UNITED STATES
NUCLEAR REGULATORY COMMISSION
OFFICE OF INSPECTION AND ENFORCEMENT
WASHINGTON, DC 20555

IE Bulletin 79-05A

NUCLEAR INCIDENT AT THREE MILE ISLAND - SUPPLEMENT

IE Bulletin 79-05B .

Figure 1

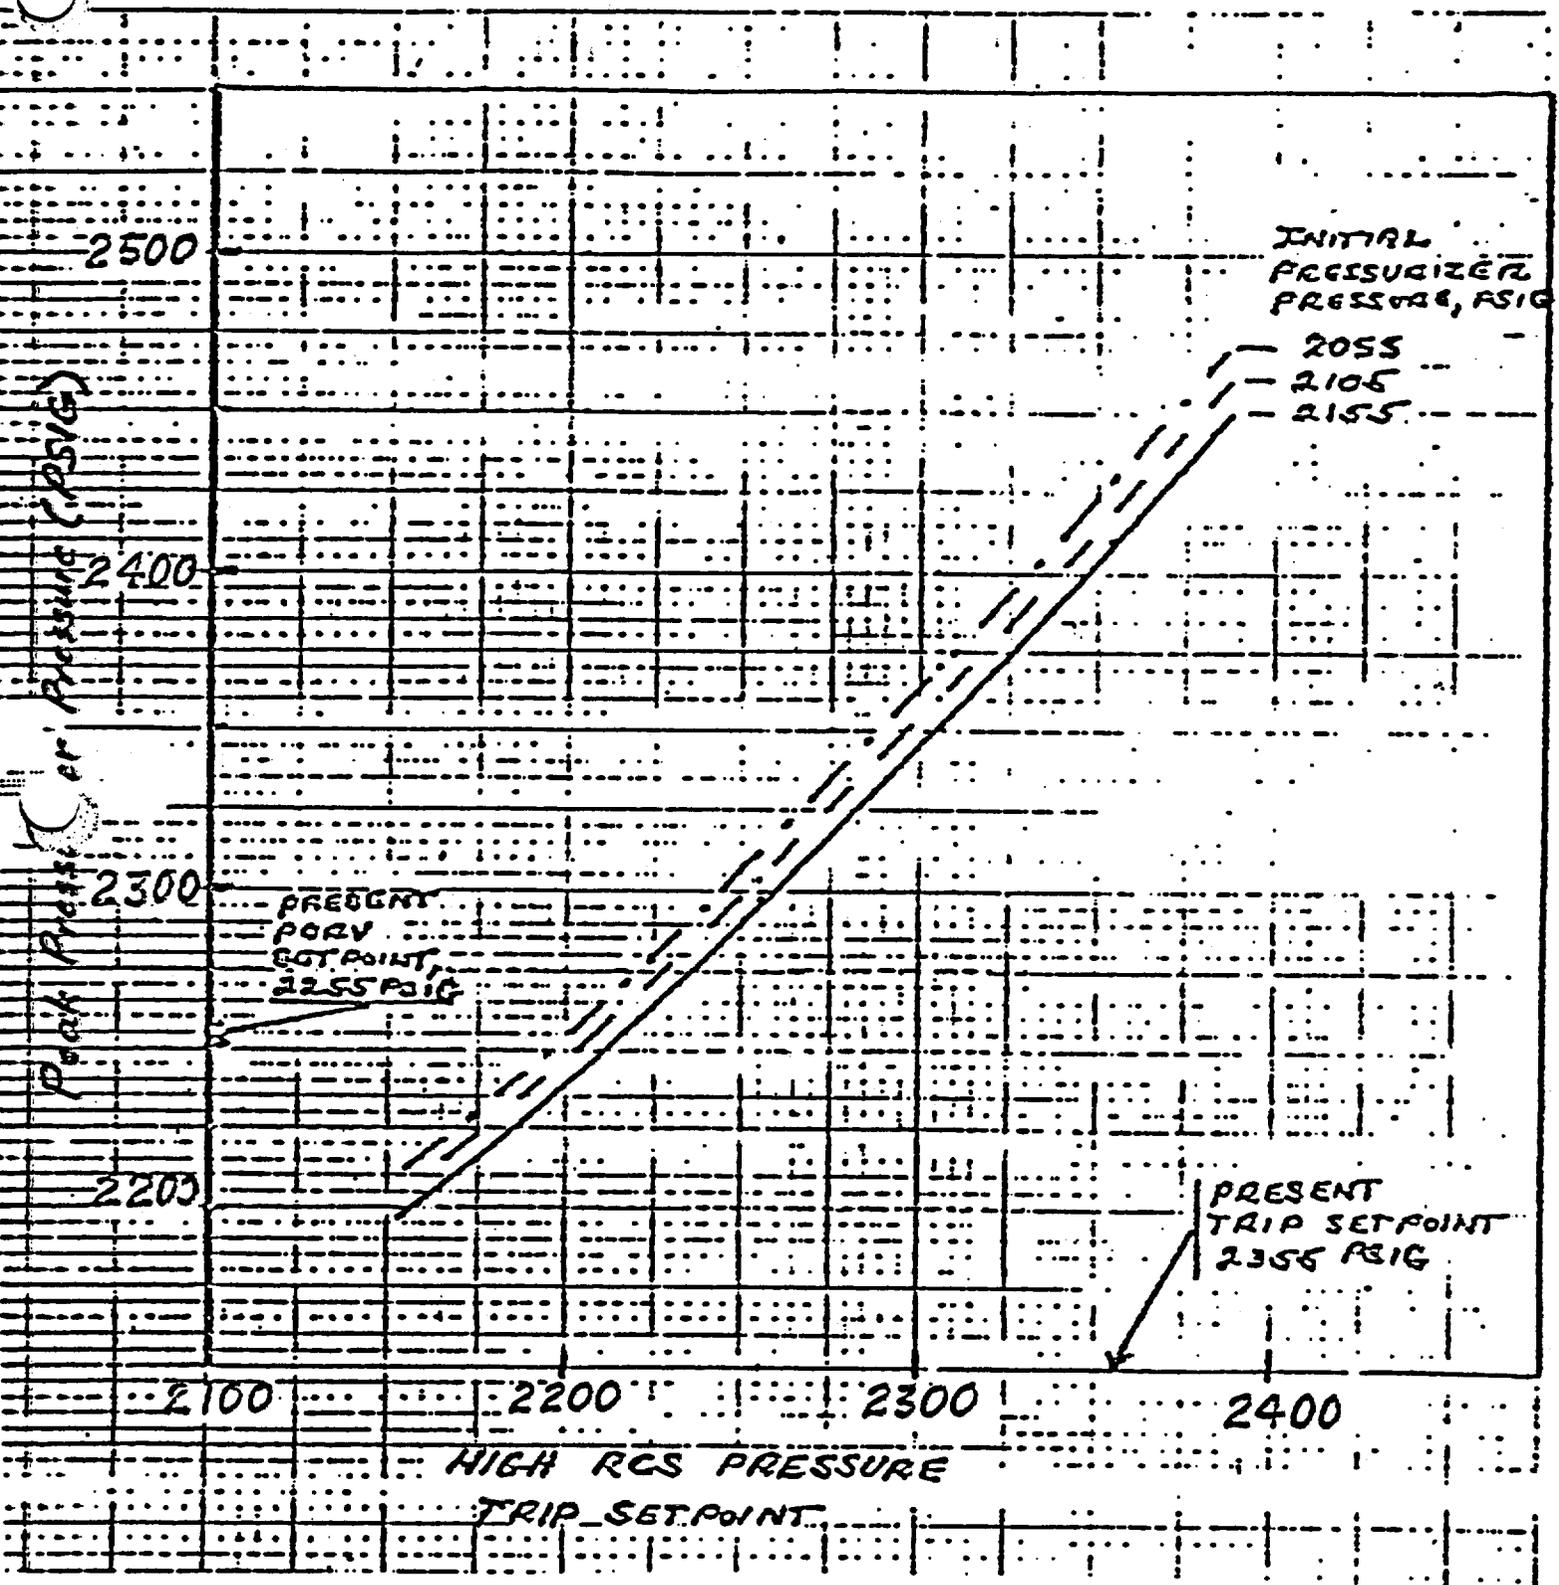
LOWERING THE HIGH PRESSURE REACTOR TRIP SETPOINT FROM 2355 PSIG TO 2300 PSIG

RAISING THE SETPOINT FOR THE PILOT OPERATED RELIEF VALVE FROM 2255 PSIG TO 2450 PSIG

The effect of changing the reactor coolant system pressure trip setpoint upon peak pressurizer pressure is typified by the attached figure 1. which was developed by B&W for a loss of feedwater transient.
